Specific Design Plan Locust Hill – Phase I

SDP-1705

STAFF REPORT

SUBJECT: Specific Design Plan SDP-1705
Type II Tree Conservation Plan TCPII-027-2015-01
Locust Hill - Phase I

ENVIRONMENTAL IMPACT

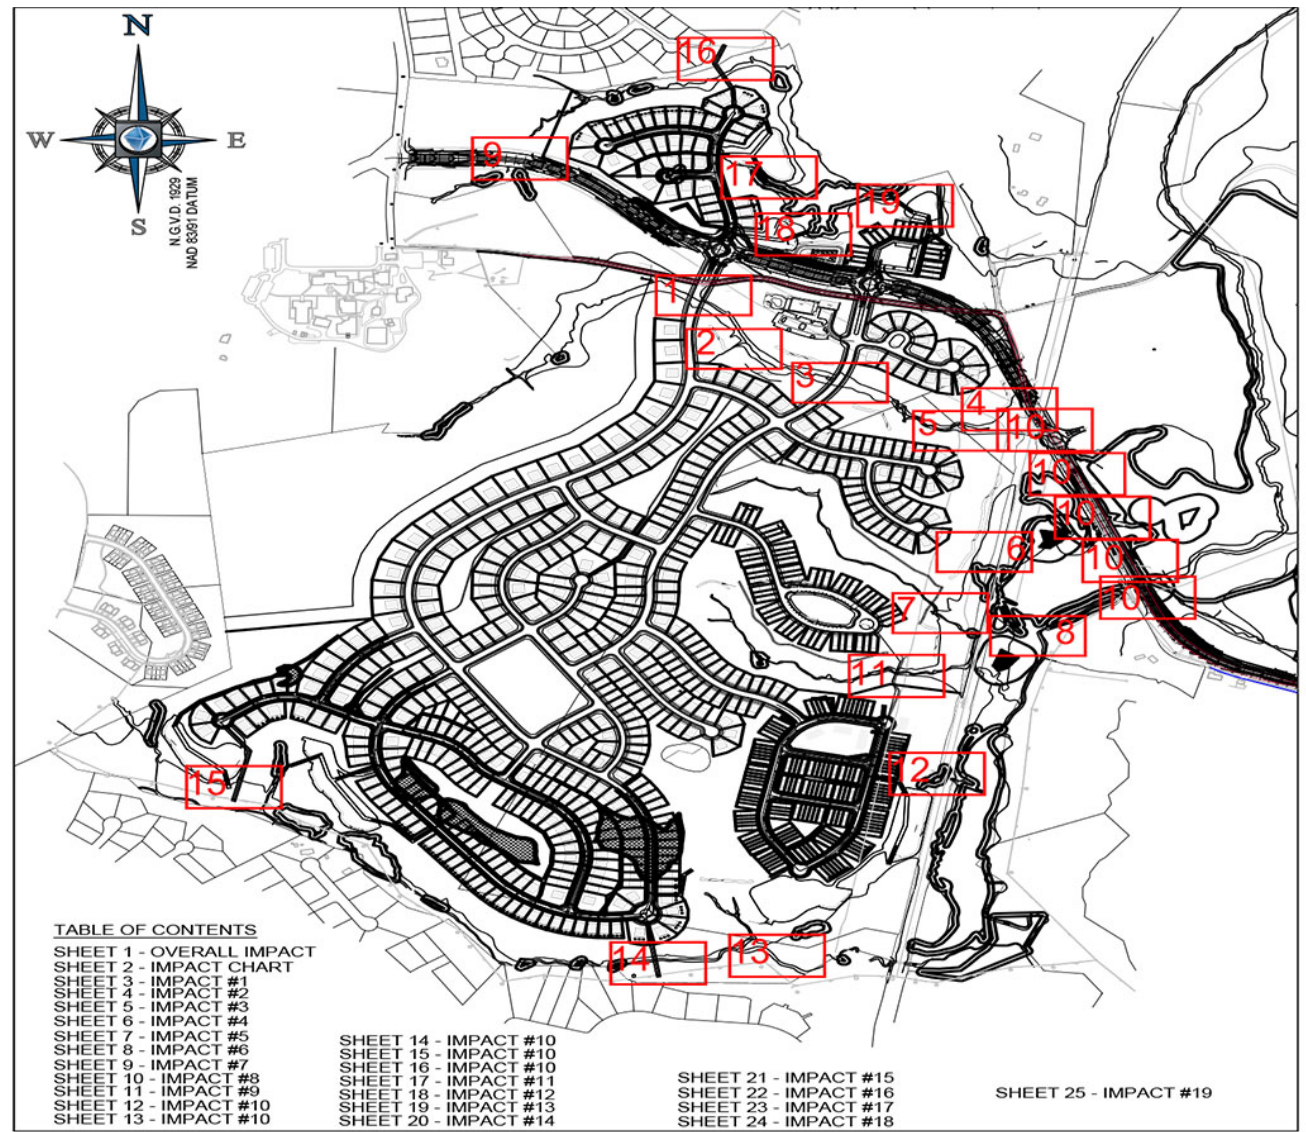
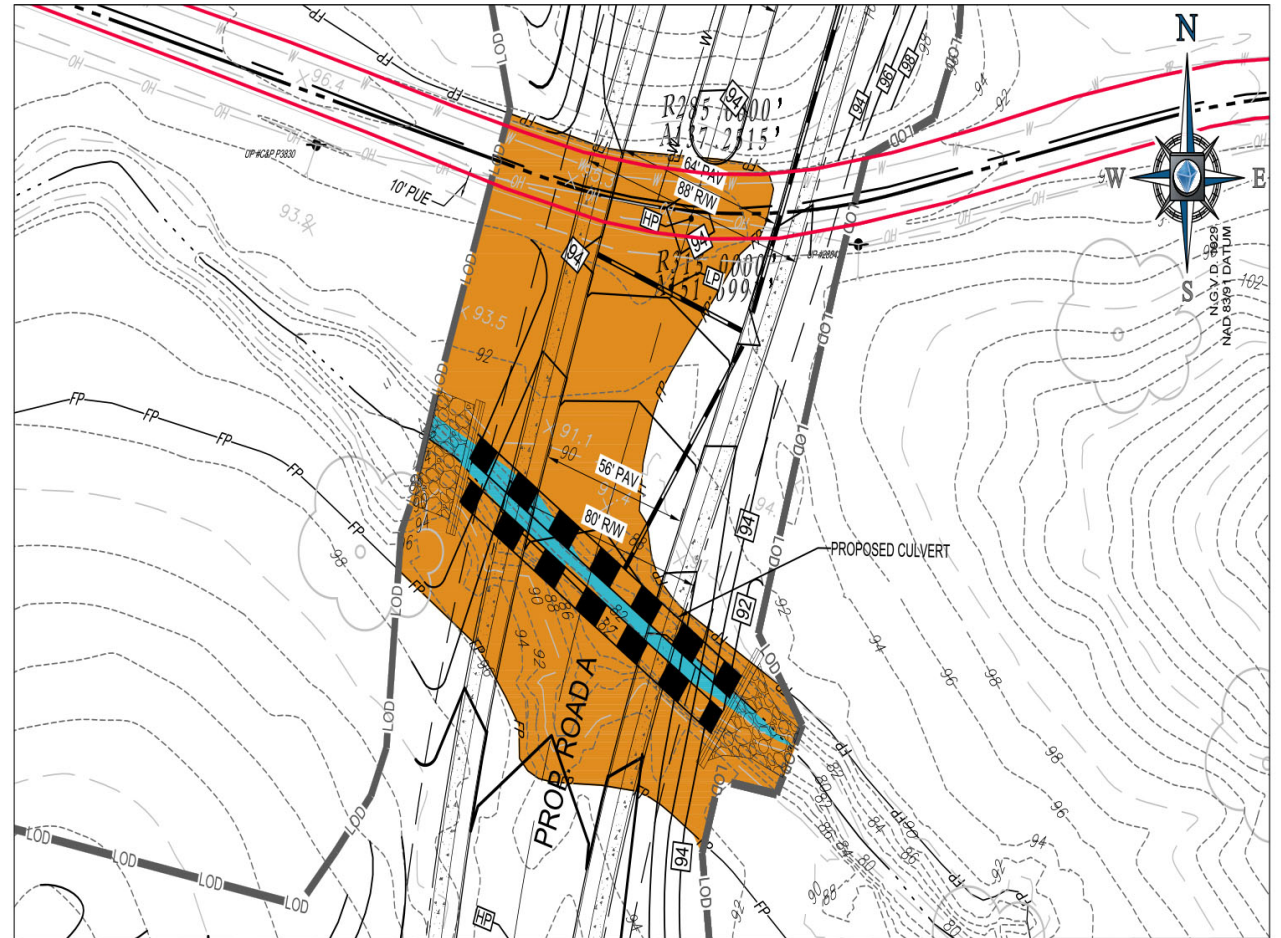
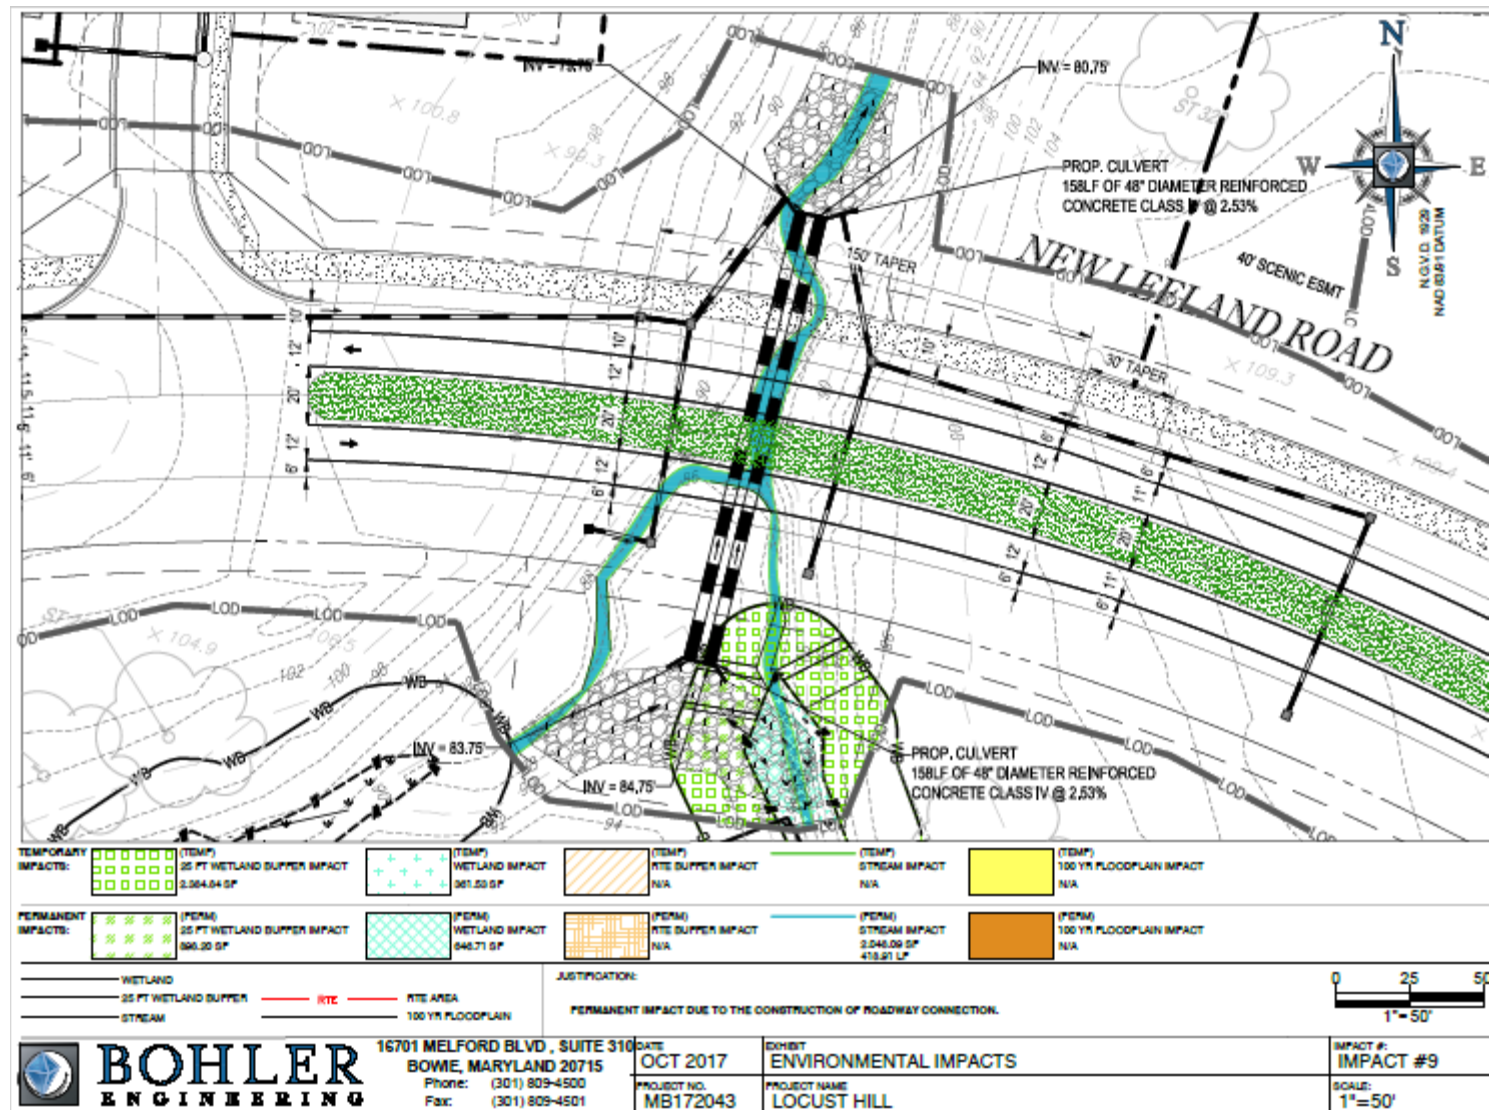
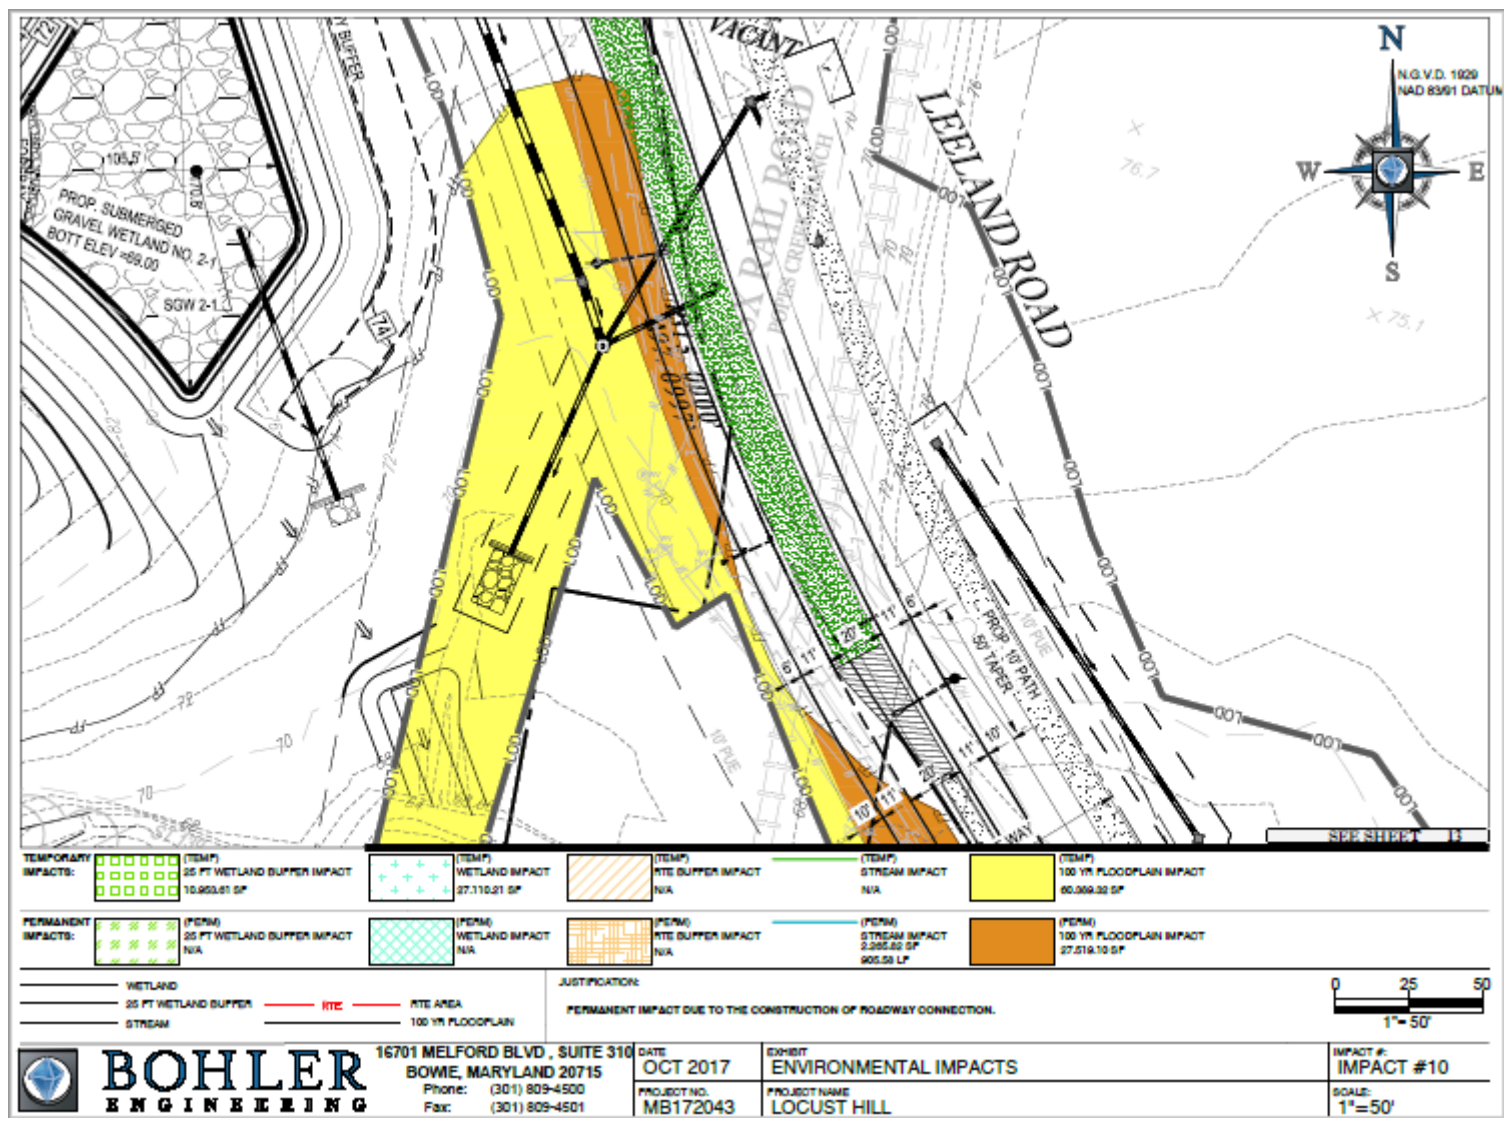
With the current SDP application, a statement of justification (SOJ) for the “modification of previously approved PMA impacts” dated February 25, 2020, was submitted on March 13, 2020. The SOJ requests approval of 20 impacts to the PMA. Justification and specific reasons for each impact is provided below. The total on-site PMA impacts proposed with Phase 1 of the Locust Hill site is 97,240.58 square feet (2.23 acres). Future PMA impacts located outside of Phase 1 will require review with the development of future phases, and modifications to impacts if necessary, will be provided with the associated development process for that phase.

A total of 298,326.72 square feet (6.85 acres) of PMA impacts are proposed, which includes impacts on the Locust Hill site and for Leeland Road/Locust Hill frontage improvements. A portion of the PMA impacts, 72,484.08 square feet (1.67 acres), was previously justified under the approved Willowbrook development (SDP-1603). After taking this into account, the PMA impacts proposed with Phase 1 development (which includes Leeland Road) is 225,478.64 square feet (5.18 acres). It is anticipated that PMA impacts located outside of Phase 1, and modification to previously approved impacts, if necessary, will be provided with the SDP for future phases.

Impacts 1, 3, 9, 10, and 10B are for impacts related to disturbance for connections to, and necessary improvements to, Leeland Road. These disturbances will allow for the realignment of the existing road at the western end of the property, development of a pedestrian/bike trail, and the installation of turn lanes at both ends to provide access to the subject property, based on master plan requirements. Due to the location of the existing and expanded right-of-way and the necessary safety improvements to the road, these impacts have been found to be minimized to the fullest extent possible.

Staff finds that the modified PMA impacts shown on the SDP are in general conformance with the impacts approved with the PPS and are generally the same size and for the same purposes as the previous approval. These impacts are necessary for construction of the proposed development and have been minimized to the fullest extent possible. Staff supports all the requested impacts.
